**November 1, 2017**

## **TCMC Emergency Department**

SA # 01593.00

**BID ADDENDUM NO. 1**

1/8" PARTIAL FIRST FLOOR PLAN - PHASING

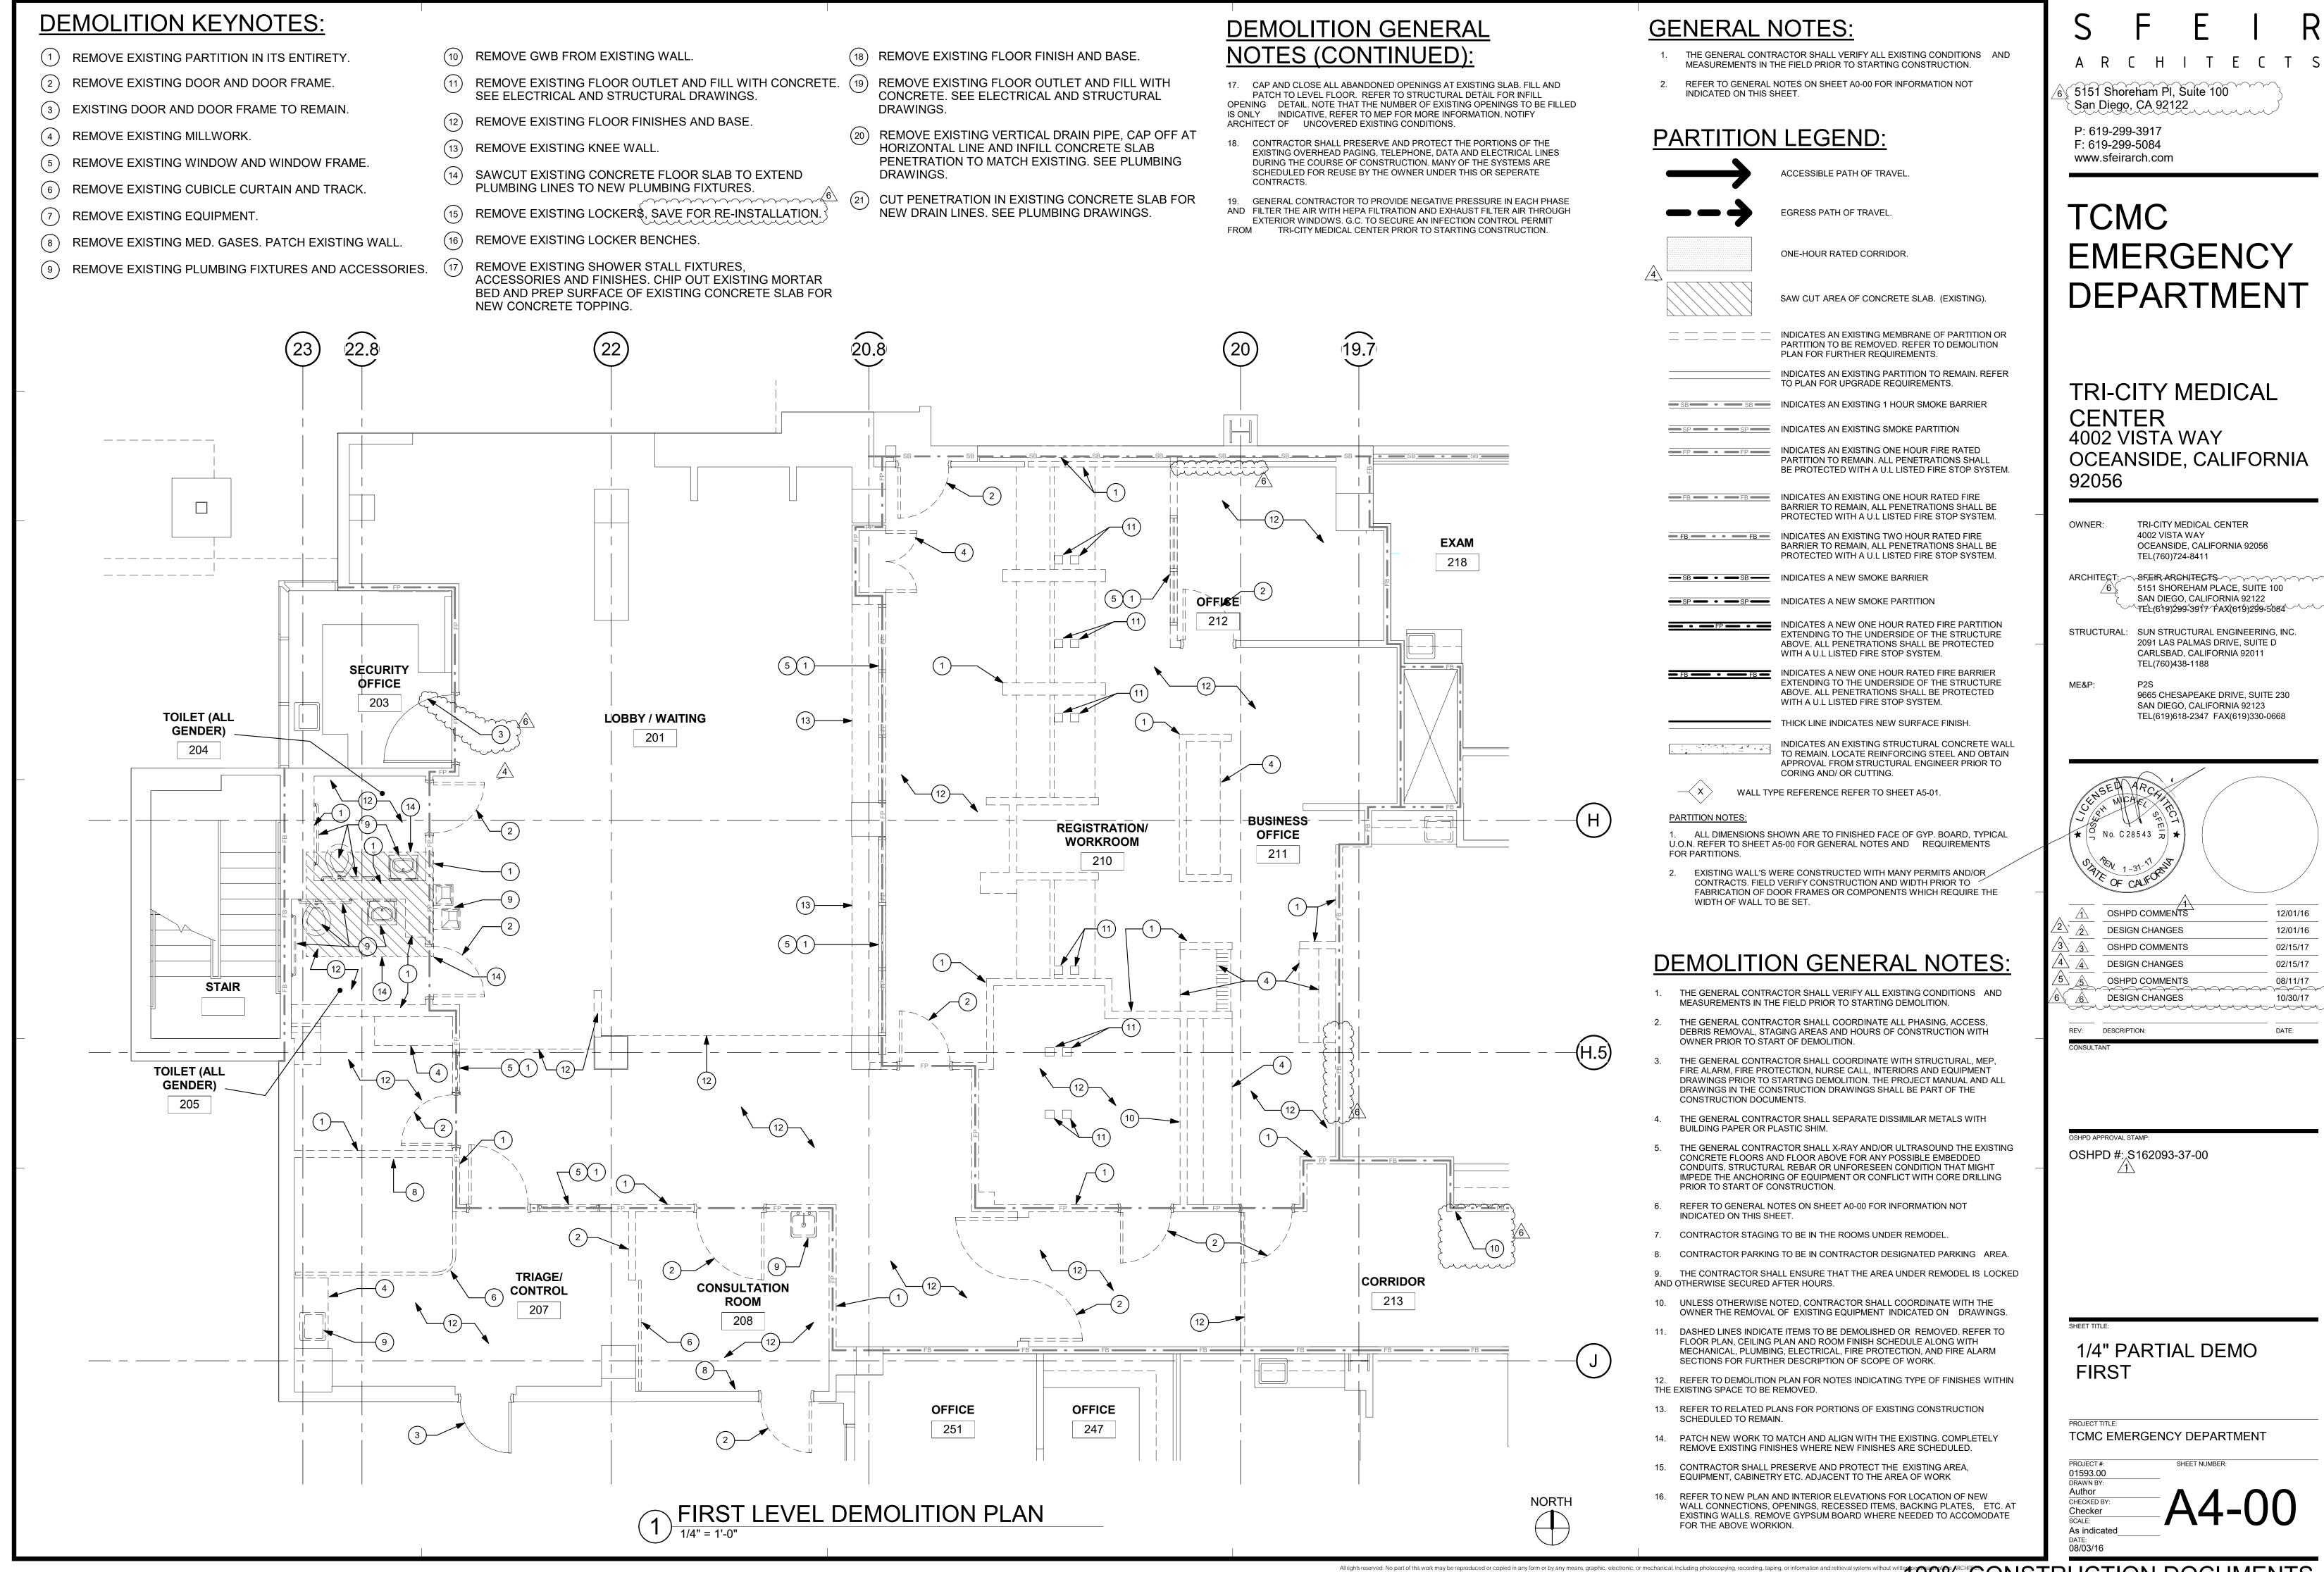
Phasing Plan Keynotes:

Add the following Keynotes:
"5 – Return infection Control partition to fascia
Below Diffusers."

"6 – Secure a weather tight enclosure."

Delete phasing Plan Keynote 2 in its entirety.

Add the following the following Keynote 2: "2 – Temporary 1 hour rated gypsum wall board partition from floor to underside of existing ceiling above".

Add Keynote 6 to removed external door.

Add Keynote 5 to Infection Partition, East of column Line 20.8.

1/4" PARTIAL DEMO

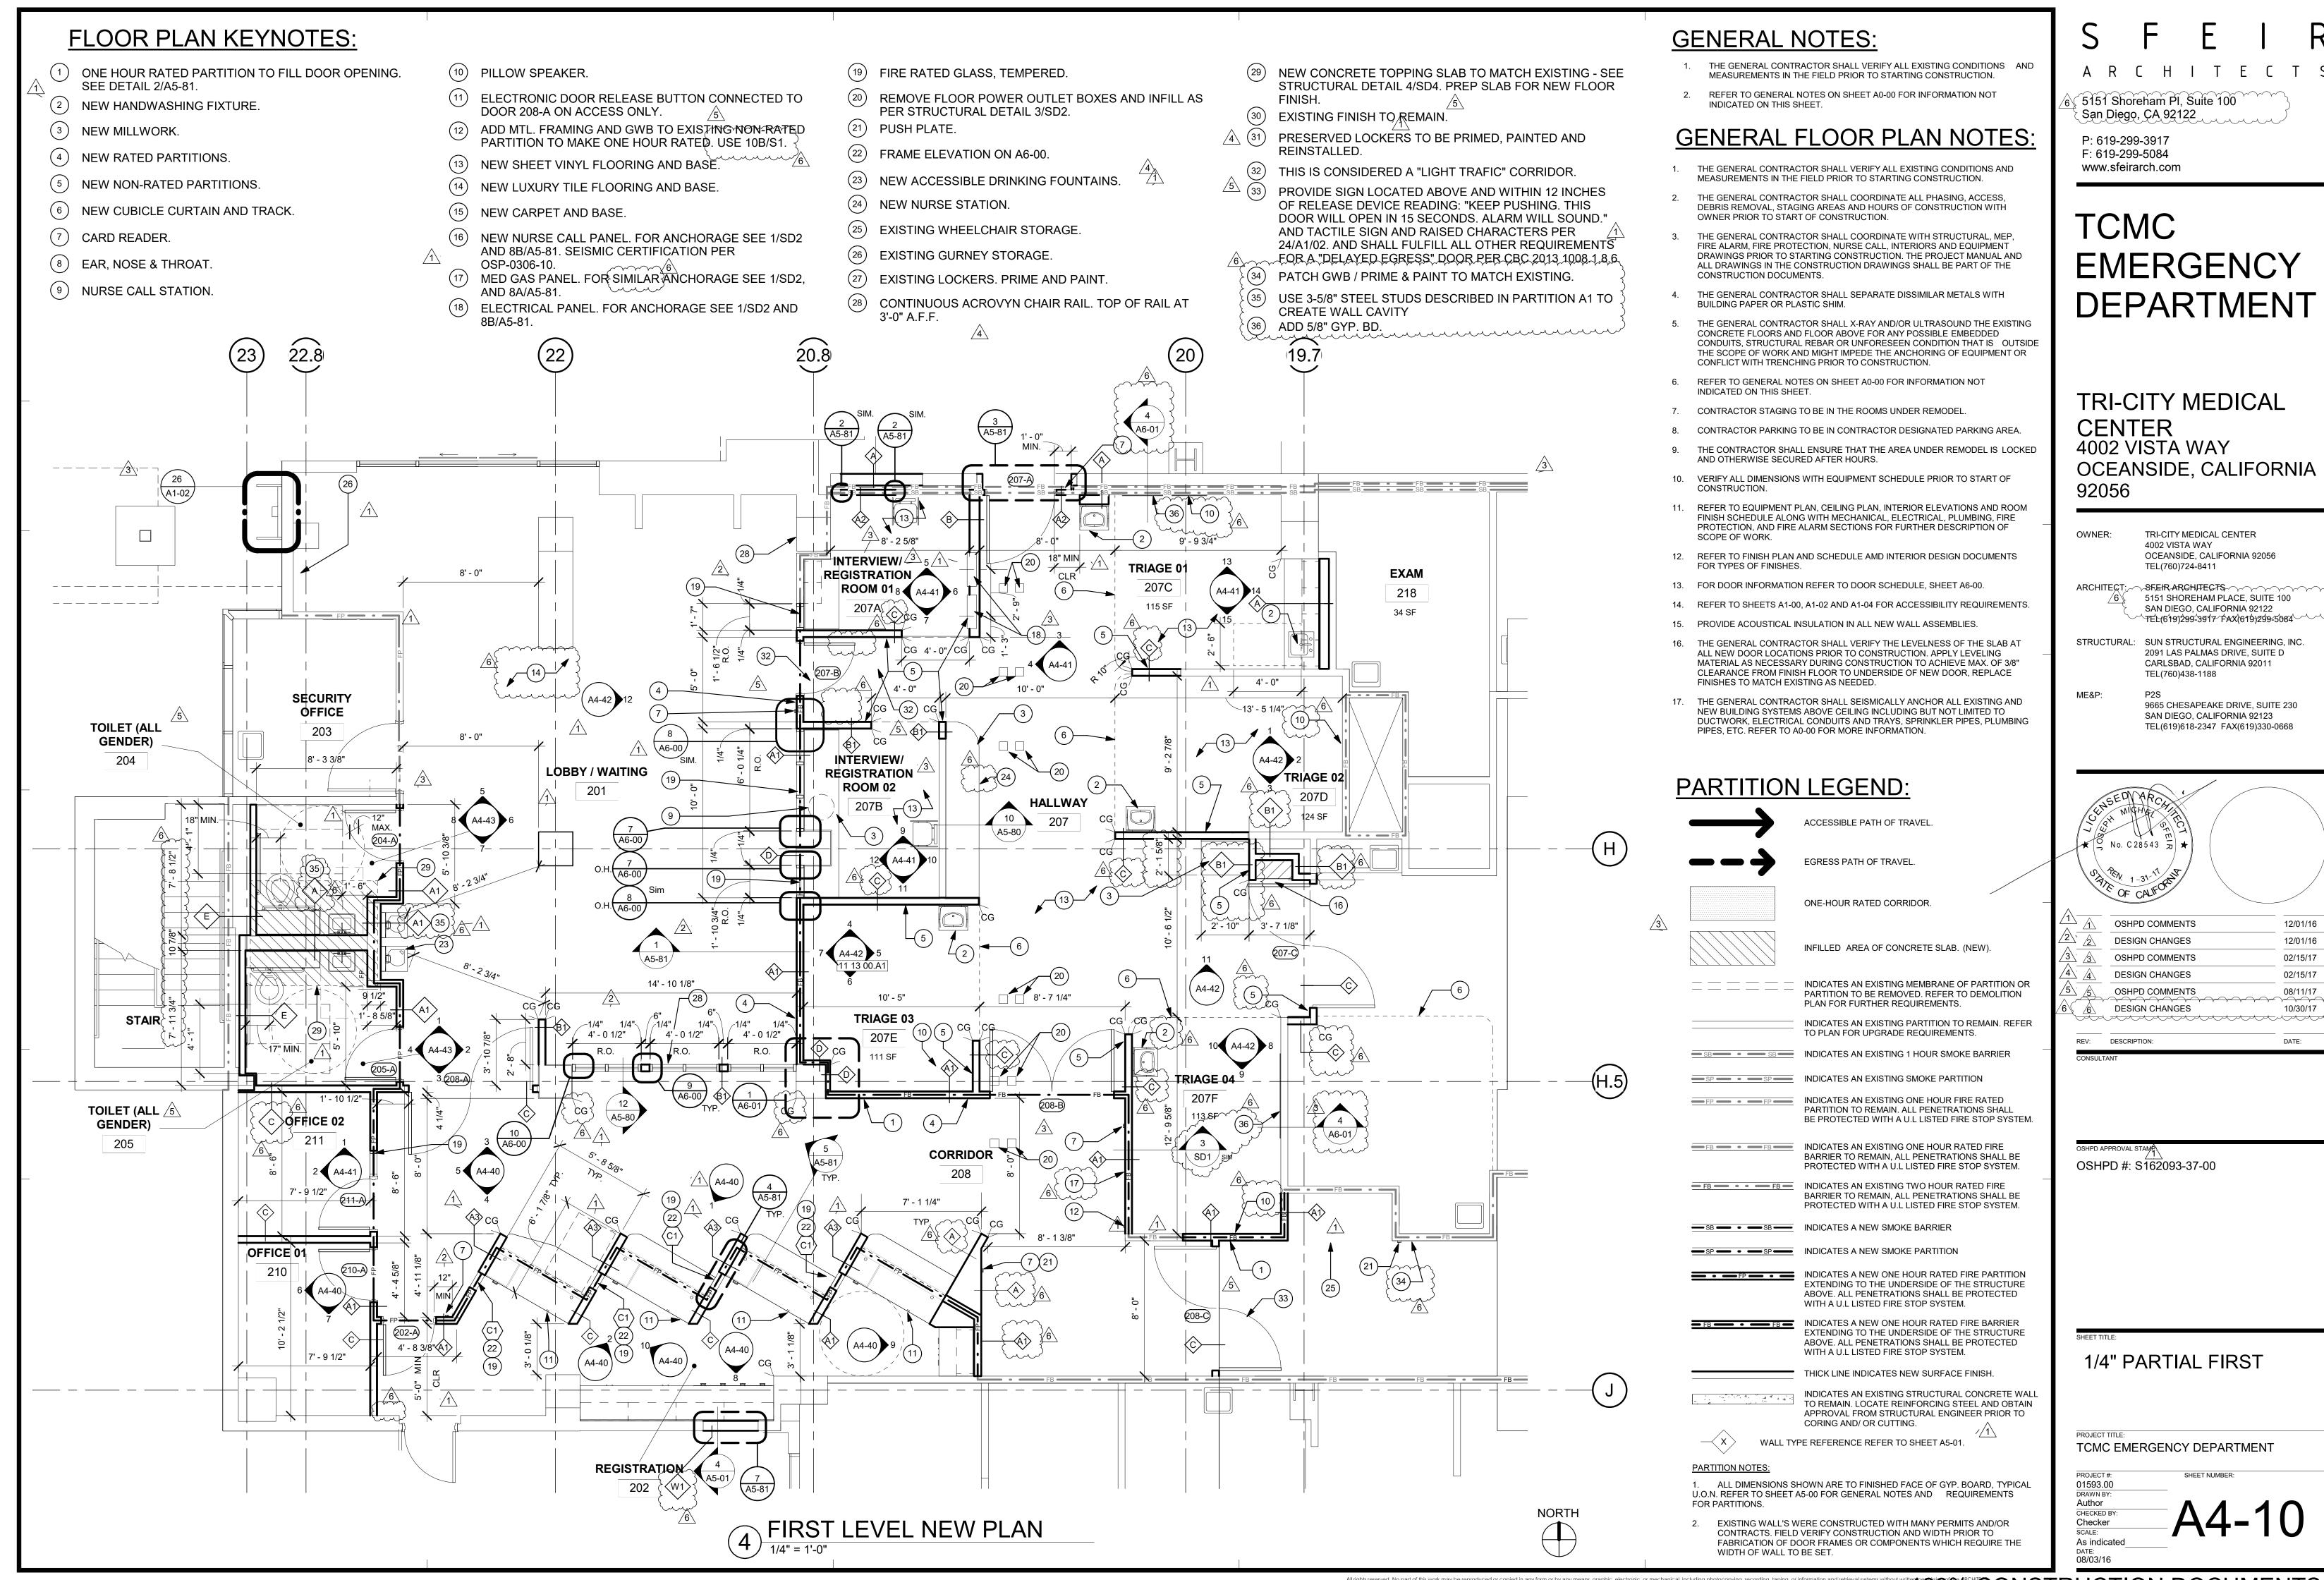
Add Keynote 3 to existing door at room 203.

Add Keynote 10 to existing partition in corridor 213.

Remove Gyp. BD North wall of Room 212 near column 20.

Remove Gyp. BD East wall of Room 211 at column H.S.

1/4" PARTIAL FIRST

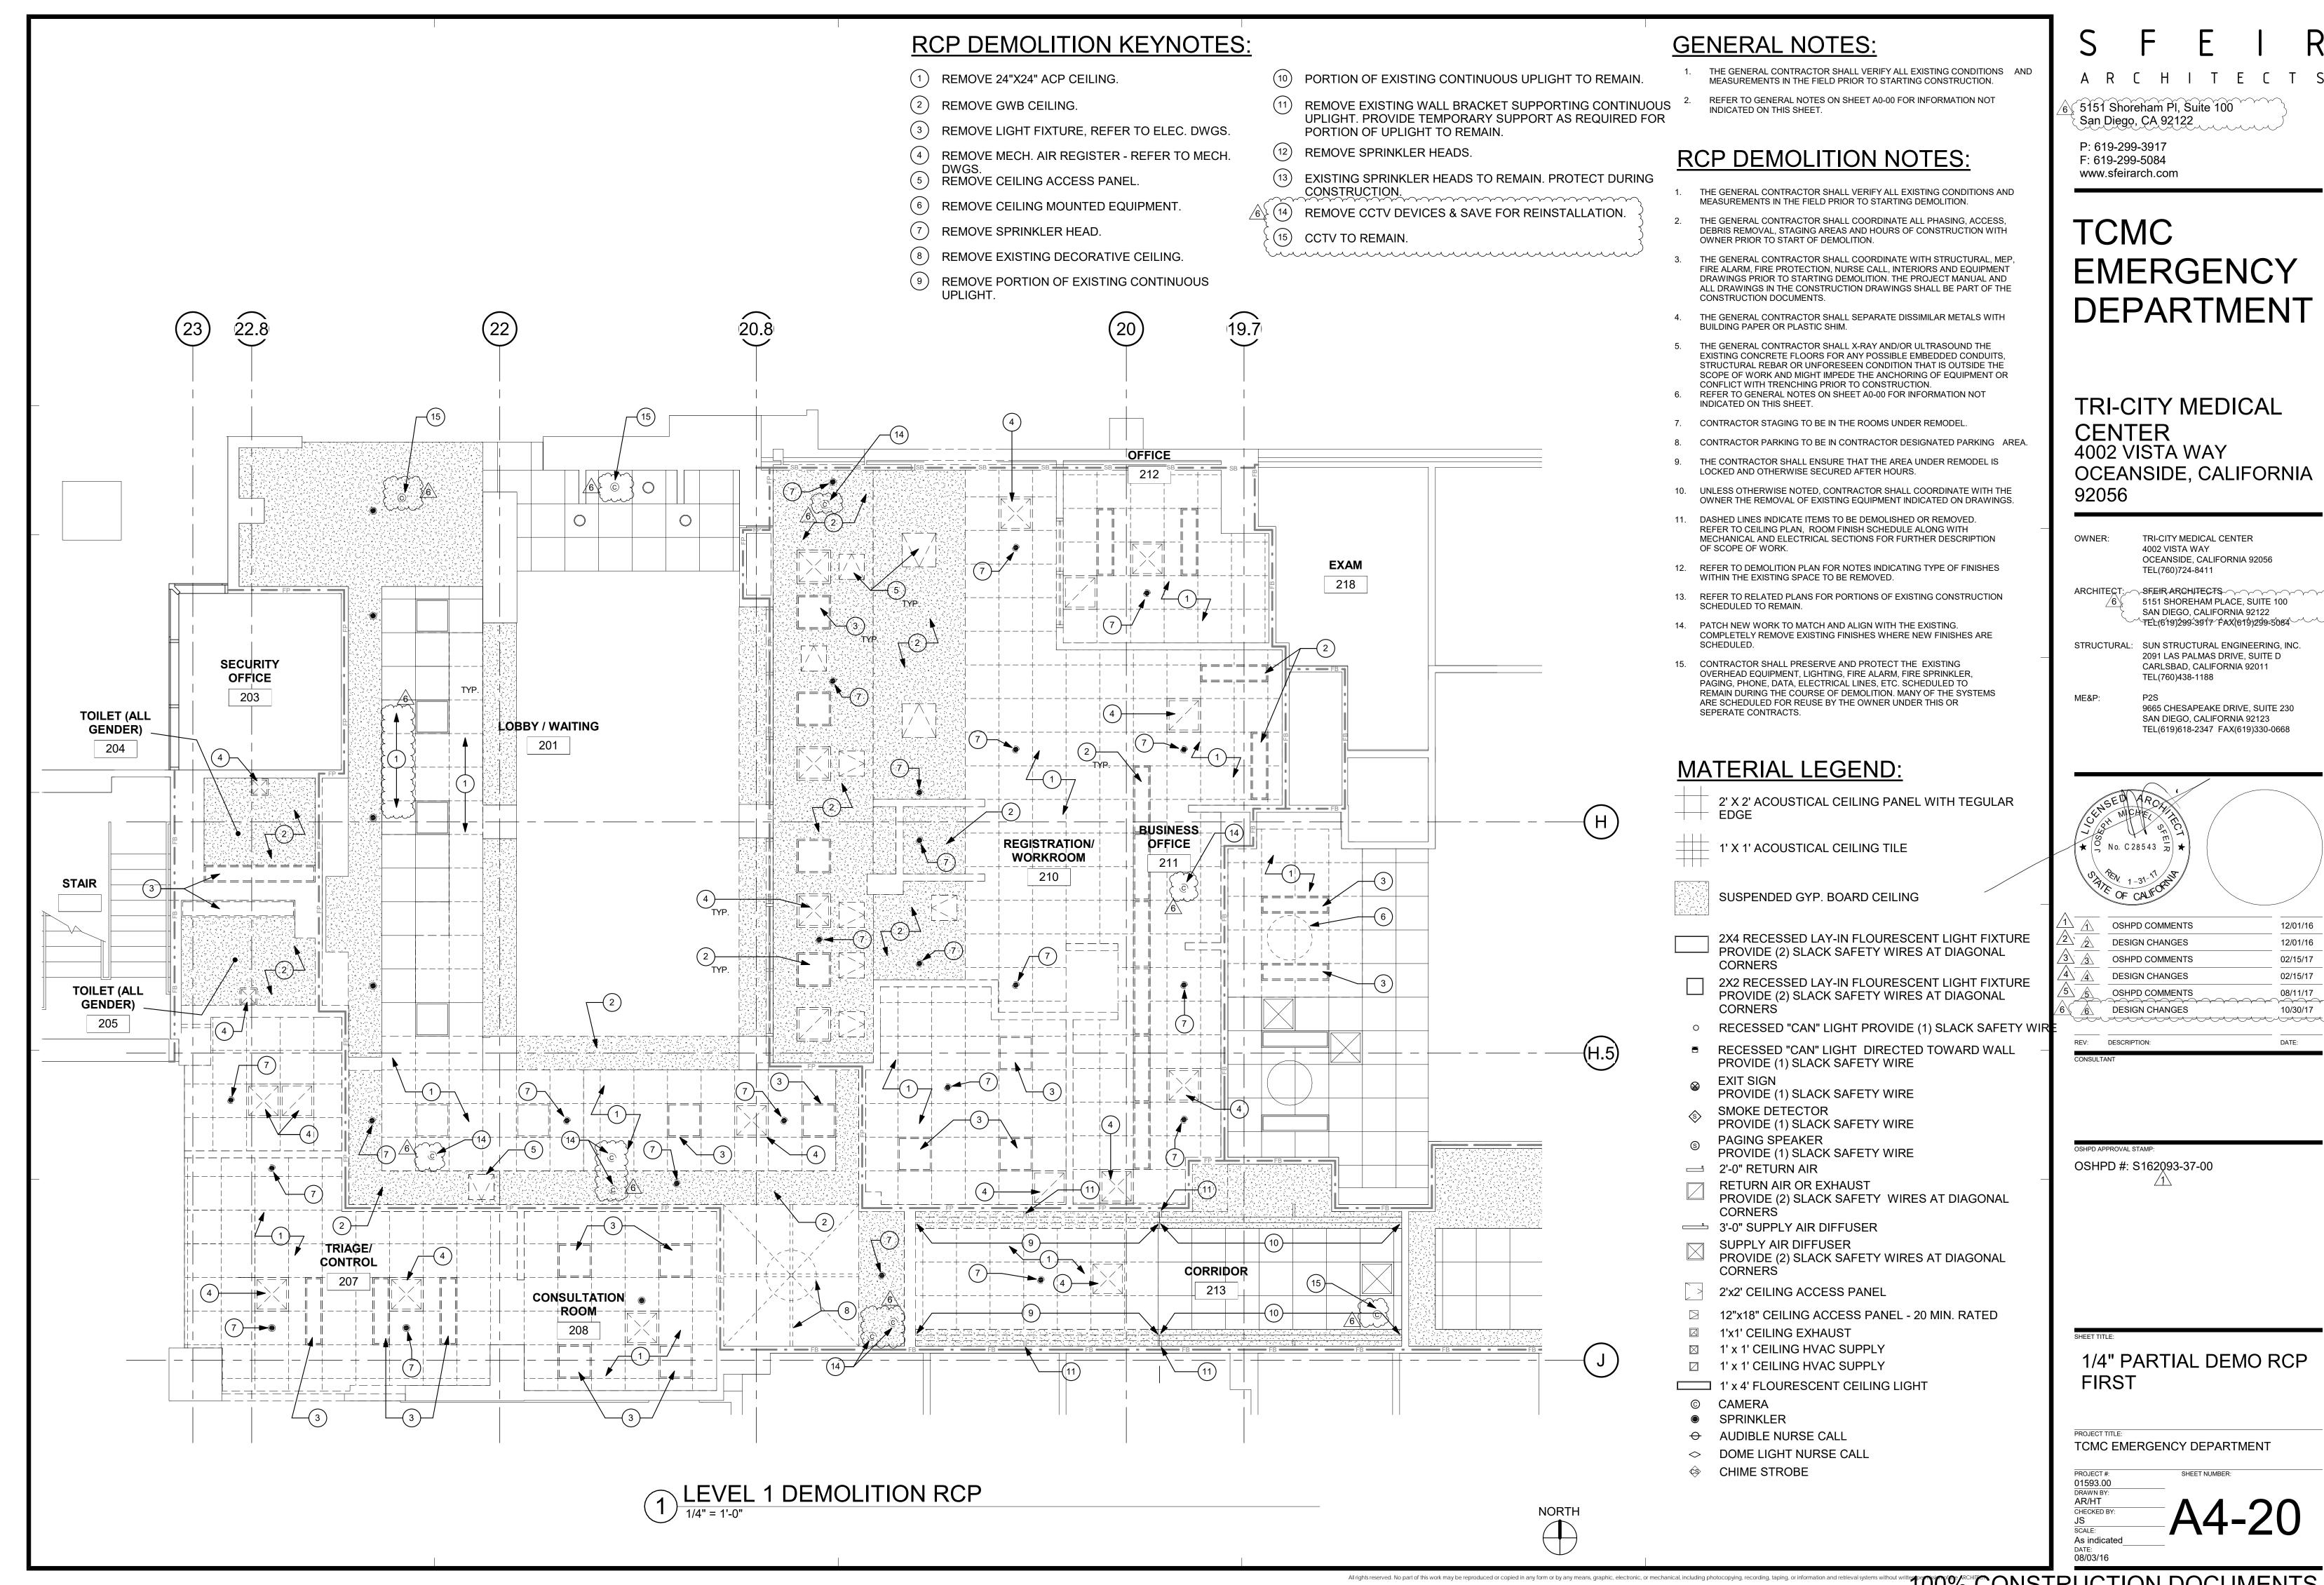
Floor Plan Keynotes:

Add the following to Keynote "12": "Use 10B/S1".

Add the following to Keynote "17": "After word 1/SD2, Add "Similar".

35 – Use 3 <sup>5/8</sup>" Steel Studs described in Partition A1 and create cavity 36 – Add <sup>5/8</sup>" Gyp. BD.

Remove all references Keynote "17" near door 207B.

Delete wall tag "B1" in Room 207A and add wall tag "C".

Add Keynote "10" to Room 207C.
